Access Compliance Report

Public Rights-of-Way

(Curb Ramps)

Intersection ID: 13872	Main Street: S_TRYON_ST	Cross Street: W_WORTHINGTON_AV	Location: W
ADA ID: DAA085A26496	Ramp Type: Perp	Initial Pass/Fail: Fail	Overall Compliance: No
		Severity Score: 12.5

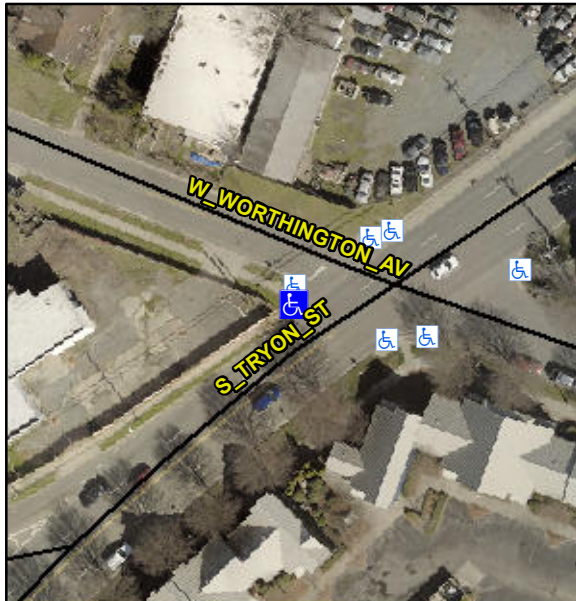
R304.5.3

Compliance	Description	Data	Compliance	Description	Data
N/A	Ramp Length (in)	92.0	Yes	Ramp Slope (%)	6.1
Yes	Ramp Width (in)	48.0	No	Ramp XSlope (%)	5.3
N/A	Flare Type LT	N/A	N/A	Flare Type RT	N/A
N/A	Flare Slope LT (%)	N/A	N/A	Flare Slope RT (%)	N/A
N/A	Flare Traversable LT?	N/A	N/A	Flare Traversable RT?	N/A
N/A	Landing Length (in)	N/A	N/A	DWS Provided?	N/A
N/A	Landing Width (in)	N/A	N/A	DWS Contrast?	N/A
N/A	Landing Slope (%)	N/A	N/A	DWS Length (in)	N/A
N/A	Landing X Slope (%)	N/A	N/A	DWS Full Width?	N/A
N/A	Landing Curb? (Y/N)	N/A	N/A	DWS Offset (in)	N/A
N/A	Shared Landing?	N/A			
N/A	Gutter Ponding?	N/A	N/A	Gutter Slope (%)	N/A
N/A	Gutter Lip Ht (in)	N/A	N/A	Gutter X Slope (%)	N/A
N/A	Painted X Walk1?	No	N/A	Painted X Walk2?	N/A
	X Walk 1 Direction	To SE		X Walk 2 Direction	N/A
N/A	X Walk 1 Width (in)	N/A	N/A	X Walk 2 Width (in)	N/A
	X Walk 1 Slope (%)	5.3		X Walk 2 Slope (%)	N/A
	X Walk 1 X Slope (%)	0.4		X Walk 2 X Slope (%)	N/A

Remove & Replace Entire Ramp.
